MODELS AFFECTED: 407

SUBJECT: MAIN ROTOR PITCH LINKS RETAINING
HARDWARE, REPLACEMENT OF.

HELICOPTERS AFFECTED: 407, Serial Numbers 53000 through 53138,
and 53140 through 53142.

Figure 1. Main rotor pitch links - Removal/installation (Sheet 1 of 2)

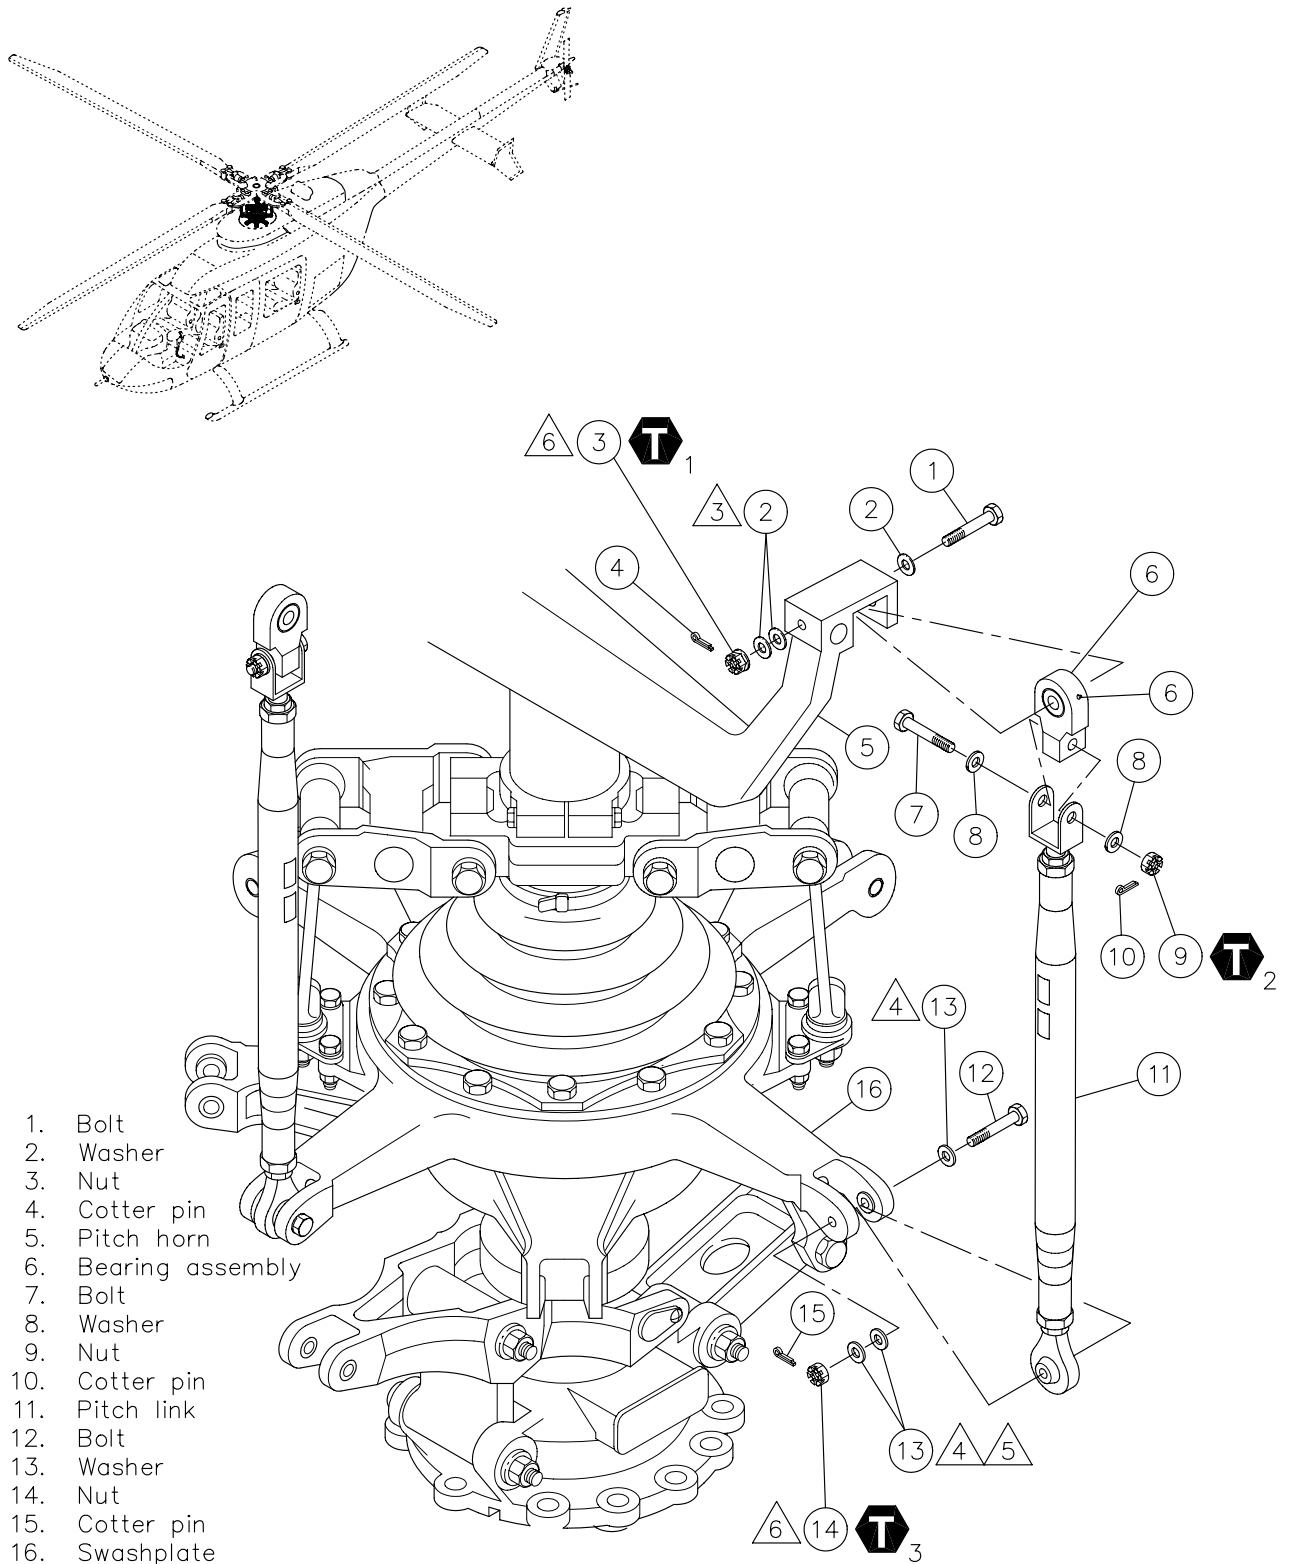
DESCRIPTION: Bell Helicopter has found that, because
of manufacturing tolerances, it is
possible that one more washer is
required under the nut of the pitch link
bolts. The added washer is to make sure
that you get the correct torque on the
nut and it aligns for the cotter pin,
without the risk of the nut becoming
thread bound on the bolt shank.

This bulletin also adds a washer under
the nut. This permits the nut to align
for the installation of the cotter pin.
The added washer also prevents the nut
from becoming thread bound on the bolt
shank.

THE MS20002-5 WASHER (13) IS THE ONLY WASHER APPROVED FOR USE AT THE PITCH LINK ROD END BEARING TO SWASHPLATE OUTER RING ATTACHMENT. THE HIGH STRENGTH MS20002 SERIES WASHER IS REQUIRED FOR THIS INSTALLATION. THE USE OF A DIFFERENT WASHER COULD CAUSE THE WASHER TO DEFORM AND THE BOLT TO BECOME LOOSE.

-  3 Make sure that when you torque the nut, you can align it for the installation of the cotter pin. To prevent the nut from becoming thread bound on the bolt shank, you can use a quantity of two (2) washers under the nut. The washer under the nut can be a thick (NAS1149F0563P) or a thin (NAS1149F0532P). You must always put the thin washer under the nut.

-  4 Make sure that when you torque the nut, you can align it for the installation of the cotter pin. To prevent the nut from becoming thread bound on the bolt shank, you can use a quantity of two (2) washers under the nut. The washer under the nut must be a MS20002-5 washer.

-  5 The MS20002 series washer does not come in a thin configuration. If you cannot align the nut for cotter pin installation while you torque the nut, it is recommended that you use a different nut until you can install the cotter pin.

1. Install the pitch link (11, Figure 1) with bearing (6) into the pitch horn (5) on the main rotor hub assembly and attach with the bolt (1), washers (2) and nut (3). Torque and safety the nut (3) with a cotter pin (4).

2. Connect the pitch link (11) rod end bearing to the swashplate (16) outer ring and attach with the bolt (12), washers (13) and nut (14). Torque and safety the nut (14) with a cotter pin (15).
3. Make an entry in the helicopter historical records to show that this Alert Service Bulletin is completed.
4. Make an entry in the Record of Alert Service Bulletins in the Maintenance Manual.
